The Highland Council

**Planning Applications Committee –
15 September 2015**

**15/00915/FUL : Mr Andrew Gunn
Land 55M West Of Newton House, Lybster**

Report by Area Planning Manager

SITE PLAN 1:500

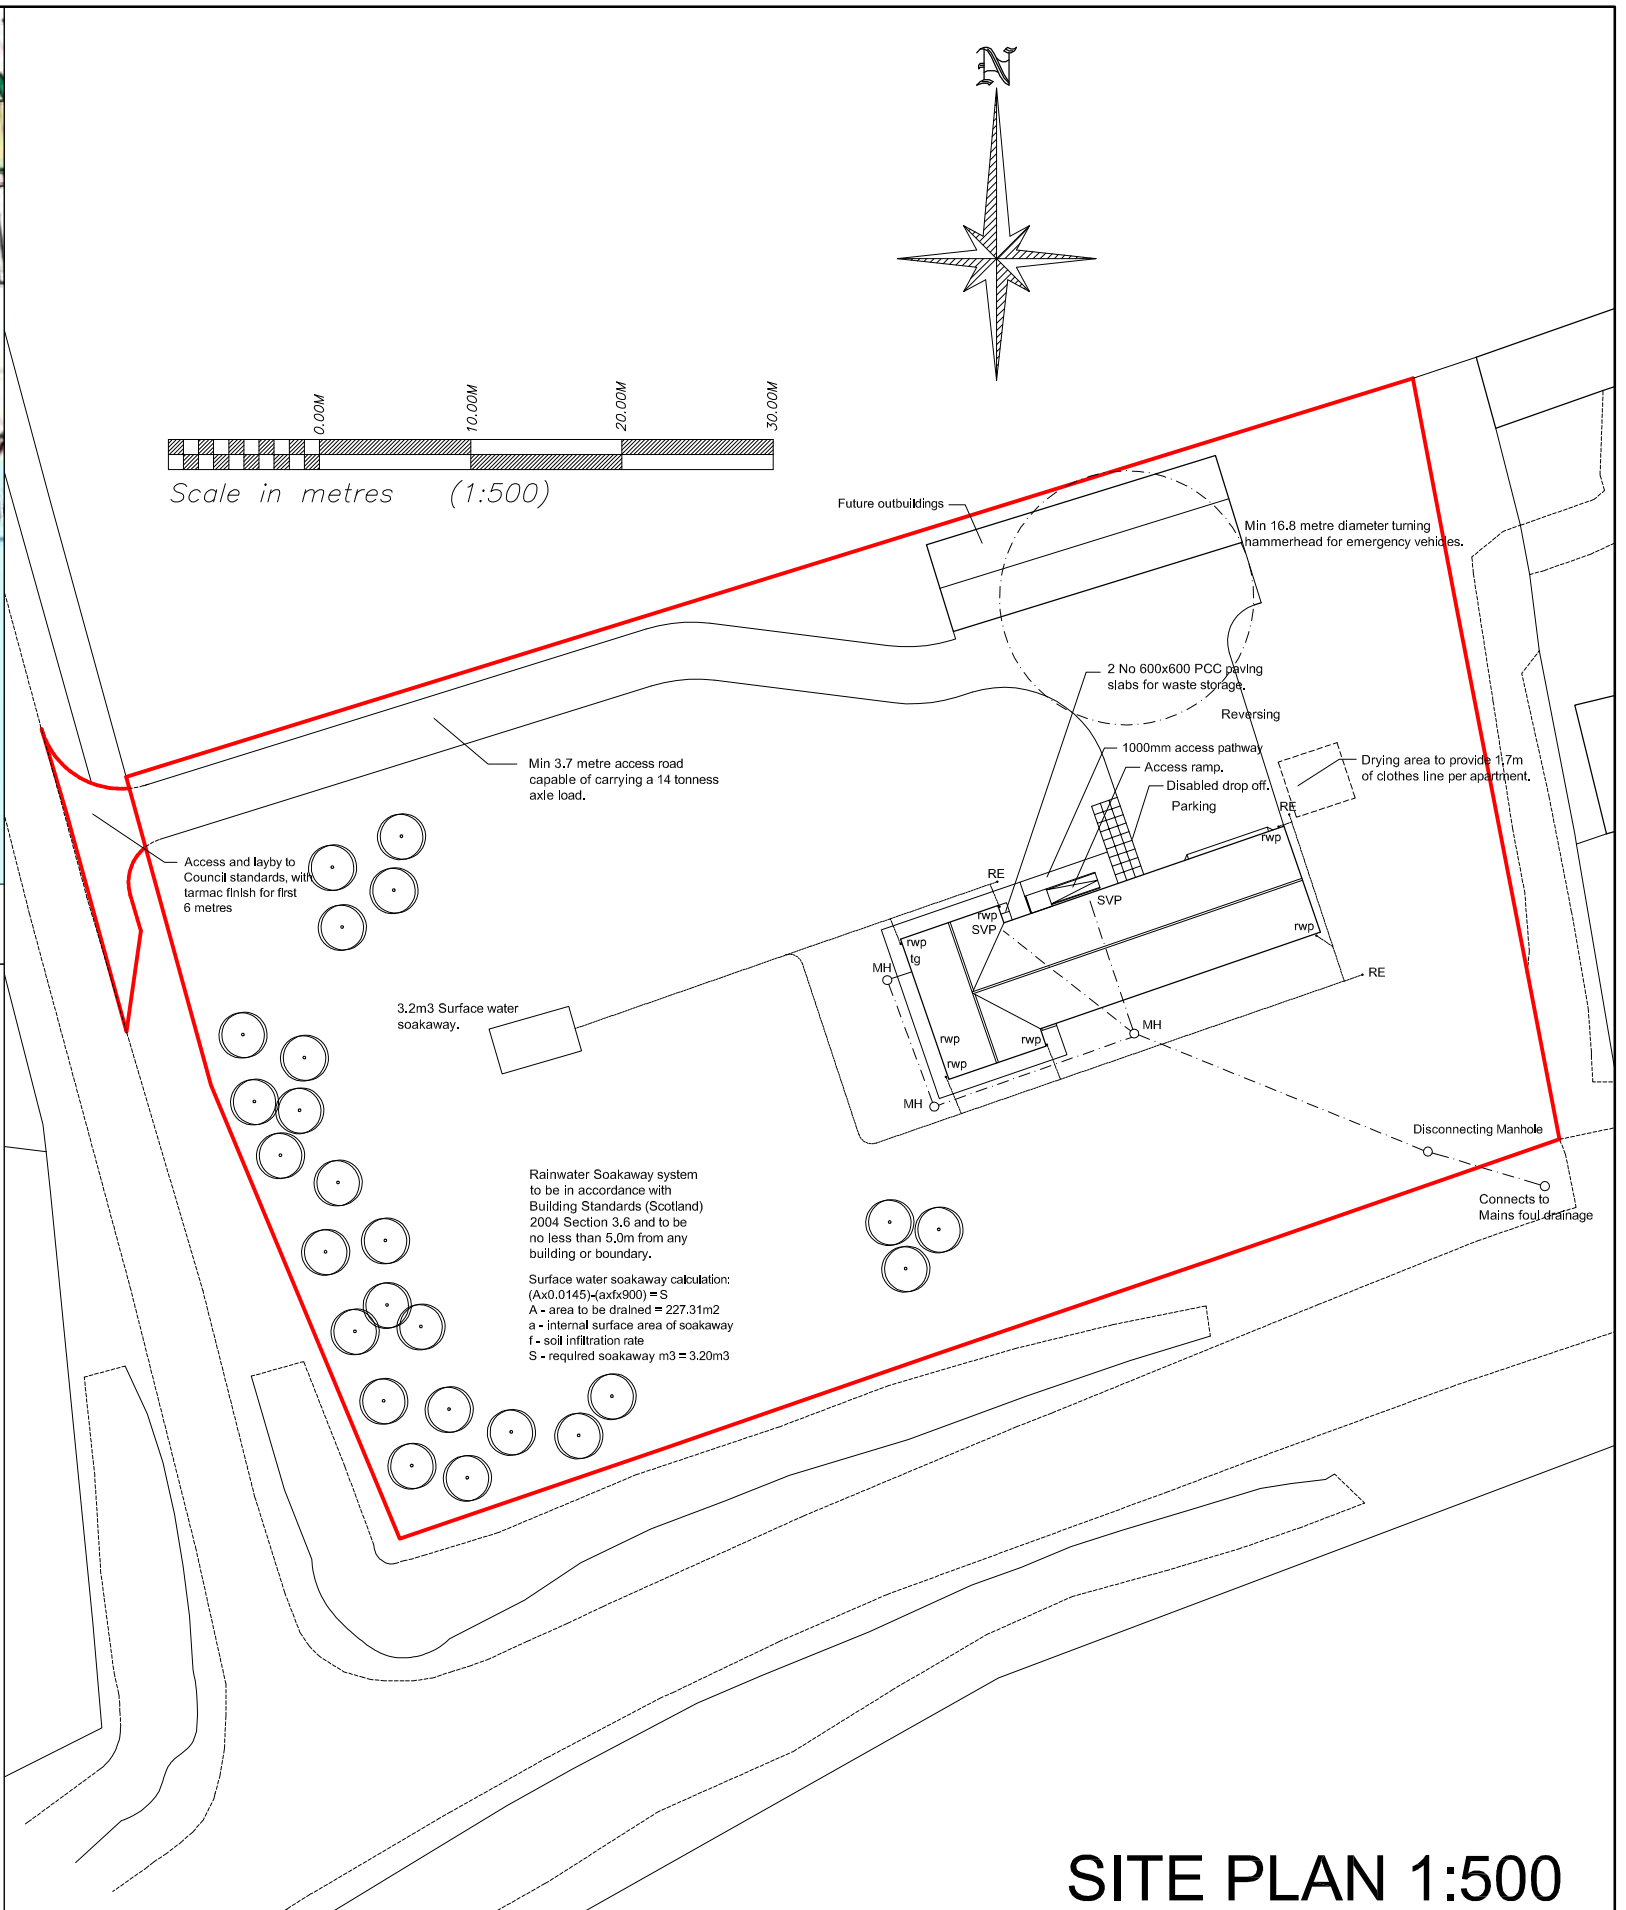
- 1.3 Vehicular access is proposed from the Lybster – Achavanich road (C1053). The applicant has stressed that any potential pedestrian access from the house may be taken towards the village within the 40mph speed limited section of the A99(T). Detail of this non-vehicular access is stated in the design statement although no mapped details of such are supplied on the location/site plan N14/17/01 Rev. A.

No alternative routes for non-vehicular access have been identified by the applicant in submitted drawings nor supporting information which avoid the likely use of the A99(T) road verge.

ELEVATIONS

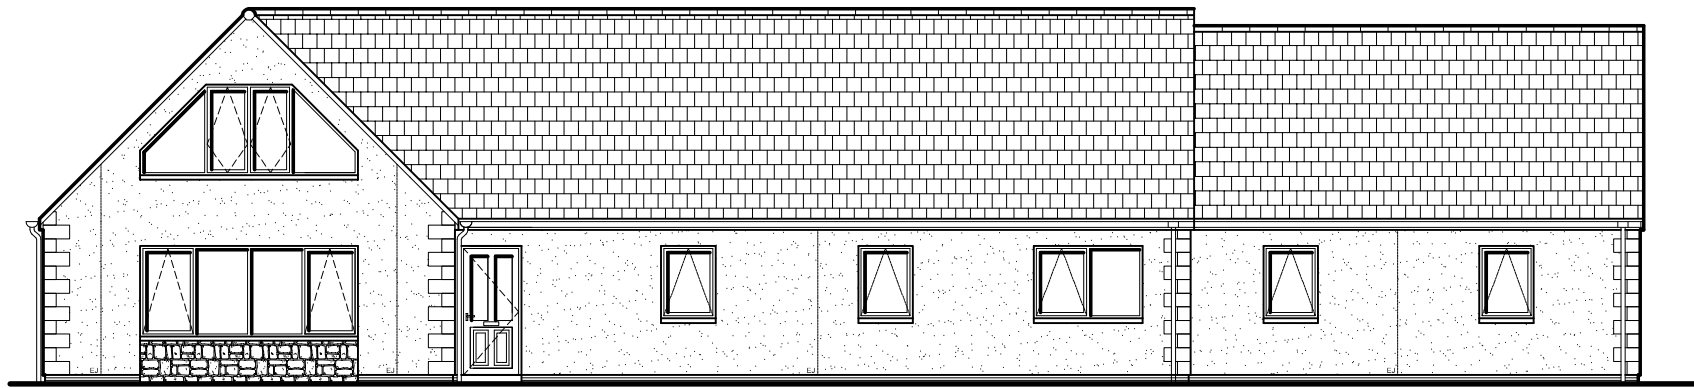
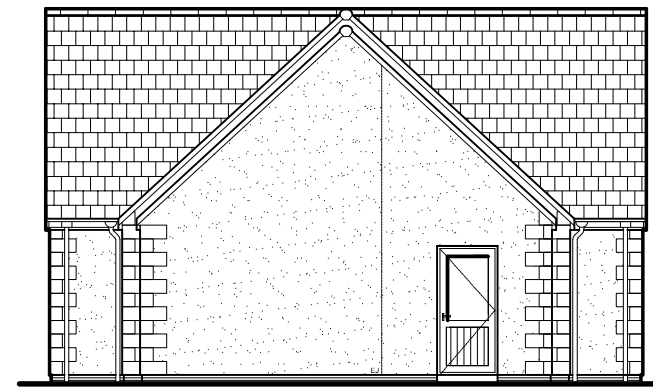
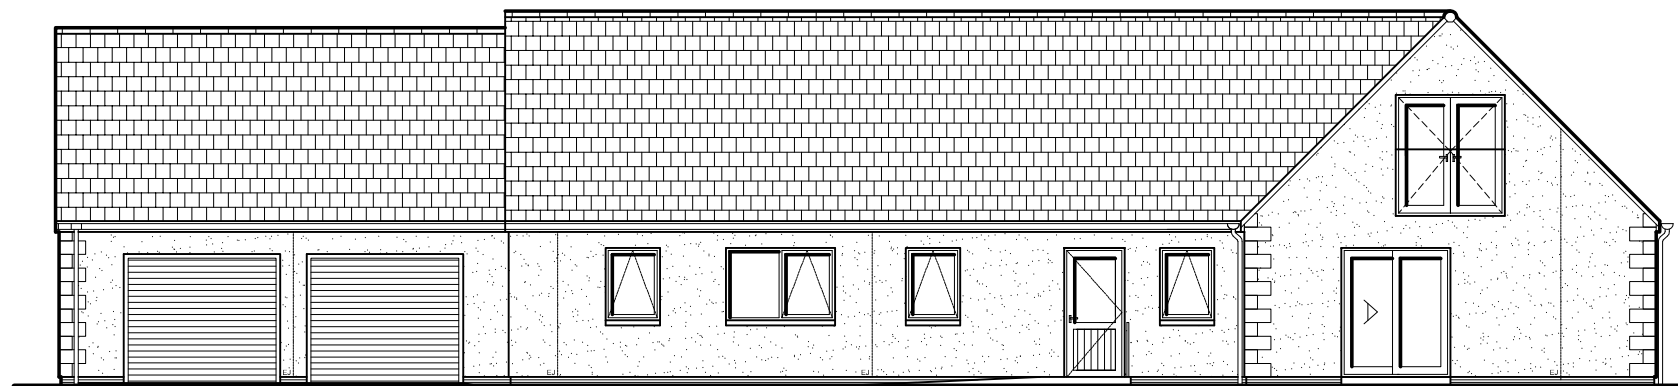
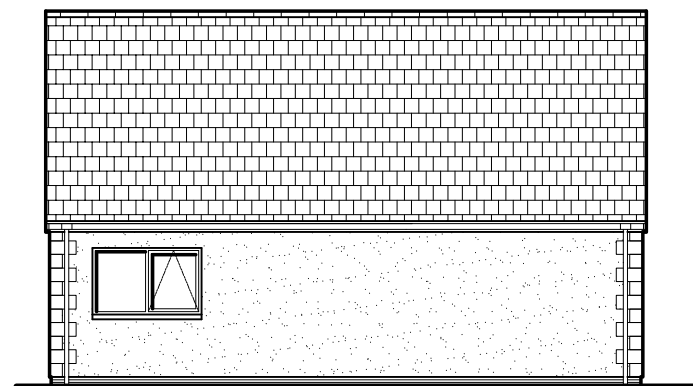
The head of the 'T' accommodates an open plan lounge/kitchen dinner at ground level with lounge area above and measures 9.8m in length with a gable of 6.8m and approximately 6m to the ridge in height. The gable of the head of the 'T' facing the A99(T) has large horizontal window openings at both ground and first floor levels which are sub-divided into vertical openings. The rest of the house is single storey with the main body of the 'T' comprising 4 bedrooms, a stairwell, utility room

In terms of materials the roof is to be finished in grey flat profile tile with wet dash rendered walls with Caithness stone quoin details on the outside corners. The windows and doors will be golden oak finished PVCu with brown rectilinear PVCu rainwater goods. Garage doors to be sectional roller type. Material finishes of the outbuilding are not specified although may be inferred to match the house given reference to the design of the outbuilding 'mirroring' the house within the submitted design statement(s).

- 8.3.9 The introduction of a development of such a suburban generic design as proposed on this prominent site would be to the detriment of the current context of substantial stone built, Victorian villas set in mature gardens with significant natural stone built walls. These traditional buildings act to both bracket and frame the entry to the western approach to the village. These buildings allied with attendant mature gardens and trees set within natural stone built garden walls provide a well defined, high quality sense of place on entry to the village from the west along the A99(T).

As noted above its setting is a key consideration in the context of the design of the historic buildings on entry to Lybster from the west. The proposed design of the house and outbuilding is a modern and bland design which is suburban in form, in this case a truncated 'T' plan, 1 1/2 storey house. It is recognised that external materials as stated do relate more to the rural than the suburban with wet dash render for walls with natural stone quoins and slate like tiles as roof finish. The material finishes will help soften the suburban form. However these finishes are insufficient to lessen the inappropriateness of this design which will not sit comfortably within the context of the existing historic properties at this entry point to the village. The developer considers that if this proposal is subject to approval the development would aid in obscuring a modern property to the north of the site as the developer considers that this is 'not in keeping with the local vernacular'. However, the basic form of this cited property is not too dissimilar from that proposed in terms of form and design. It is also of note that this property is separated from both the A99(T) and the settlement boundary which significantly alters the context of this other property from the one under consideration.

Proposed Outbuilding Elevations

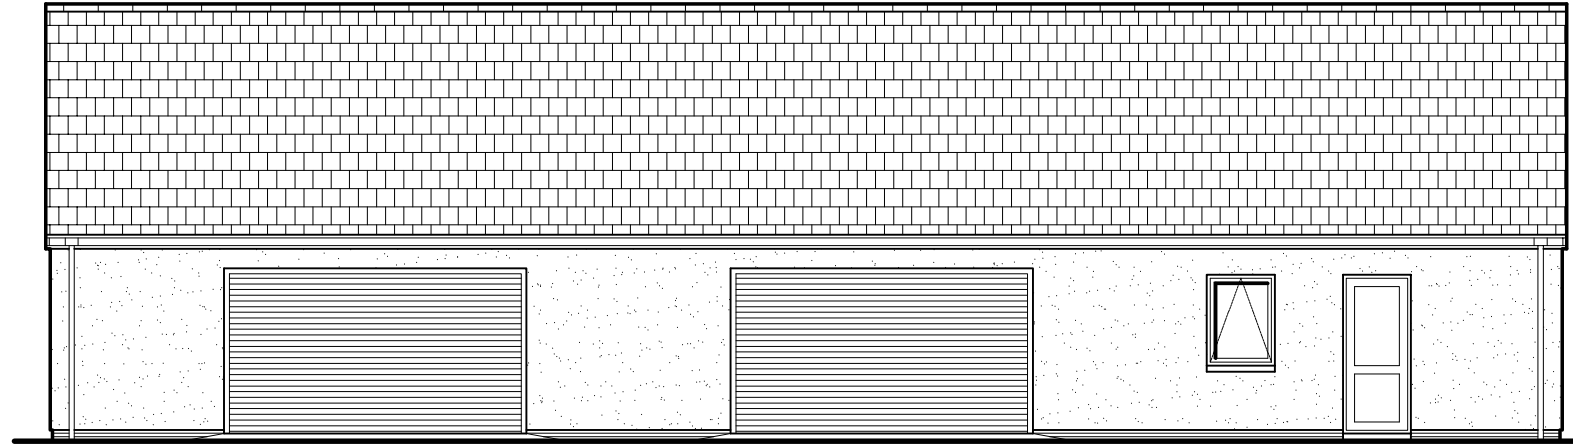
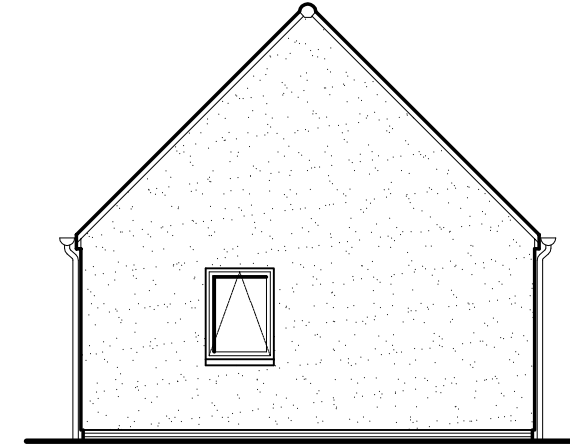
A separate single storey outbuilding measuring approximately 19.7m in length, and 6m in width is proposed parallel to the house and located adjacent to the north boundary of the site. This outbuilding also has two double width garage doors. No floorplan has been submitted to further identify the internal layout and use of this outbuilding. It has a footprint is 118 square metres.
